Proposal for the 06 series of amendments to UN Regulation No. 78 (Braking of Category L vehicles)

Submitted by the experts from the Netherlands and the International Motorcycle Manufacturers Association

The text reproduced below is based on ECE/TRANS/WP.29/GRVA/2023/4, adopted by GRVA during the week of this session (15th session). It includes, in blue, amendments to the approval number and marking provisions, referring to the series of amendment. It is submitted to GRVA for final adoption in view of submission to WP.29 and AC.1 for consideration in June 2023.

Model A

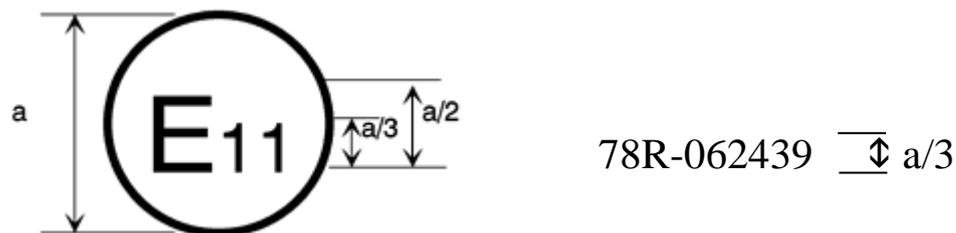
Annex 2, amend to read:

The above approval mark affixed to a vehicle¹ shows that the vehicle type concerned has, with regard to braking, been approved in the United Kingdom (E 11) pursuant to UN Regulation No. 78 under approval number **062439**. The first two digits of the approval number indicate that UN Regulation No. 78 already included the **06** series of amendments when the approval was granted.

Model B

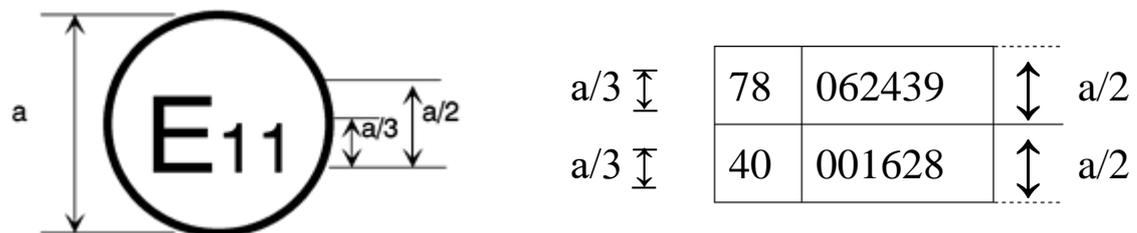
The above approval mark affixed to a vehicle shows that the vehicle type concerned has been approved in the United Kingdom (E 11) pursuant to UN Regulations Nos. 78 and 40.² The first two digits of the approval numbers indicate that, at the dates when the respective approvals were granted, UN Regulation No. 78 included the **06** series of amendments but UN Regulation No. 40 was still in its original form.”
